YL-KTN/778

APPLICATION FOR PERMISSION
UNDER SECTION 16 OF
THE TOWN PLANNING ORDINANCE
(CAP.131)

Project:
Planning Application
at Lot 122/RP
in DD109

Section 16-1 Planning Application No.TPB/A/YL-KTN/778
at Lot 1227 RP in D.D.109

Plan 2

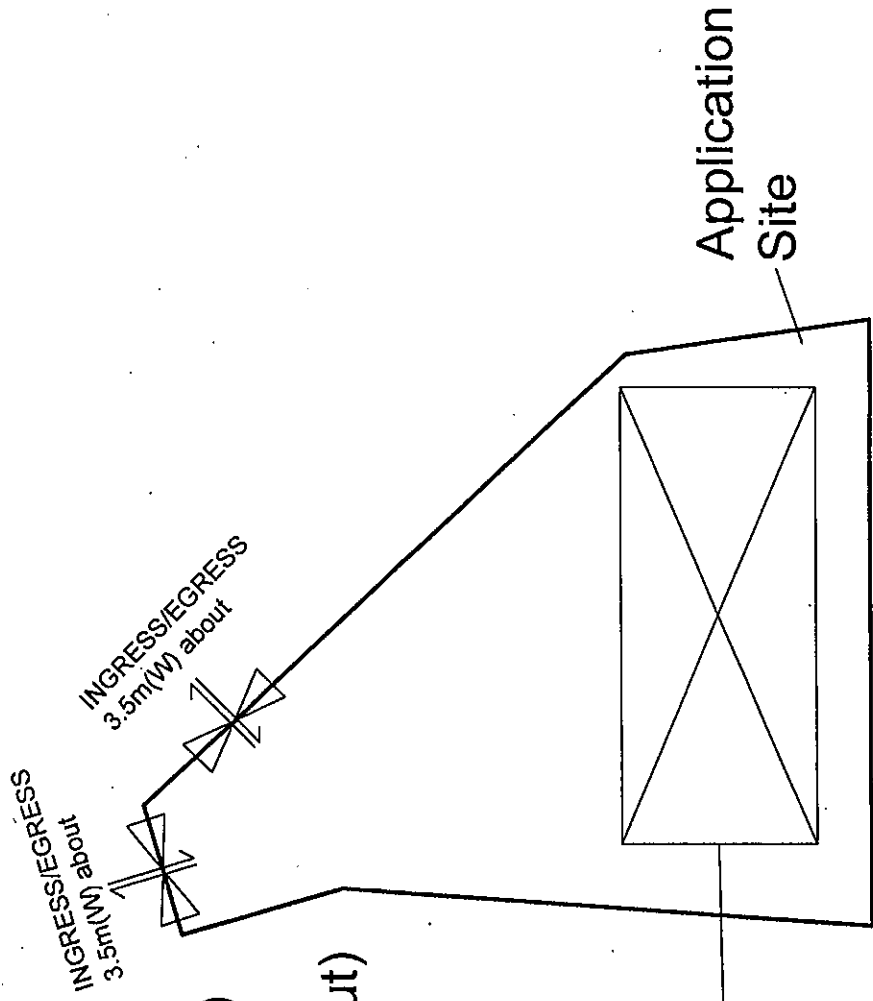
2.Please provide the mPD of land filling (i.e. from XX mPD to XX mPD)

3.Provide full justifications for the required paved area and demonstrate why the paved area is necessary and why not other alternatives such as soil/sand ground.

- From +5.75mPD to +5.90mPD.

- Concrete paving is the exiting paving condition of the site. Concrete paving is also convenient for cleaning purpose.

Swept Path analysis for
loading/unloading by light
goods vehicle only

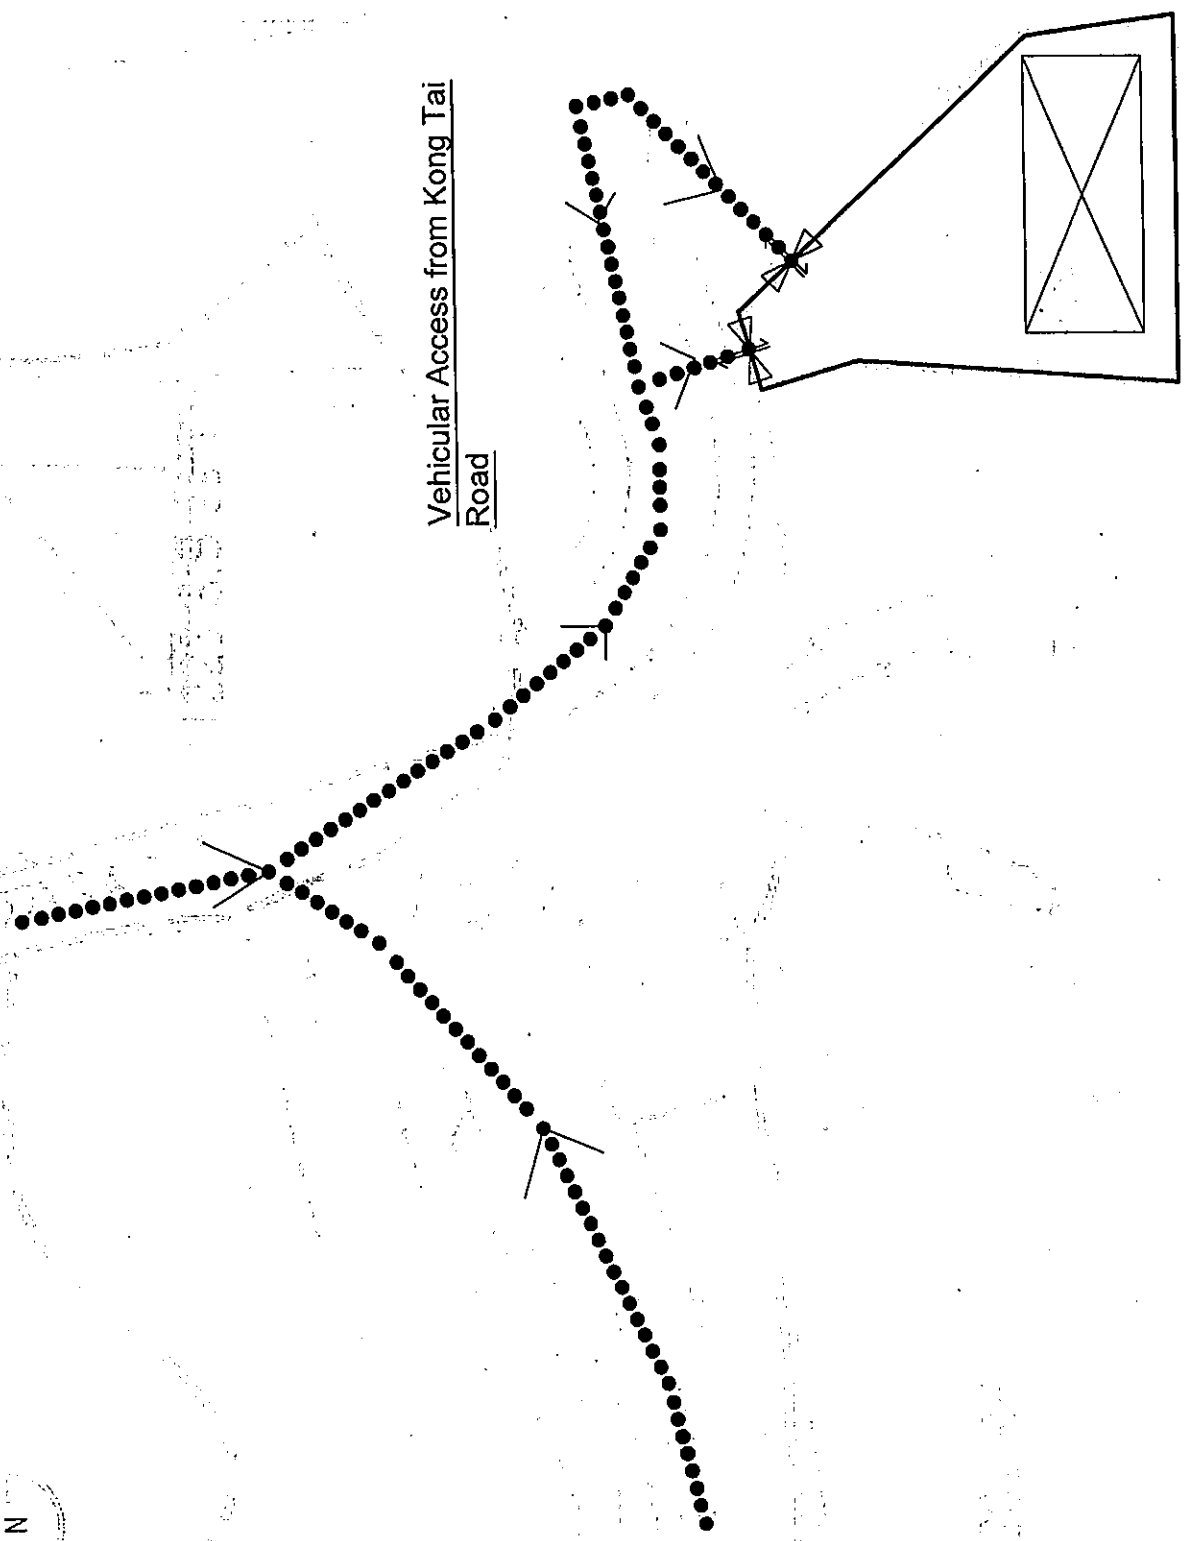
- a) The applicant should justify the proposed parking and loading / unloading considering the commute of staff/visitors & logistics;
 - There is no proposed parking space, please find the enclosed drawing showing the swept path analysis of light goods vehicle for loading/unloading purpose.
- b) The applicant should provide nearest public transport services and indicate on the layout plan; and
 - New territories GMB Route no.602 is the nearest public transport service to the site , plan is enclosed.
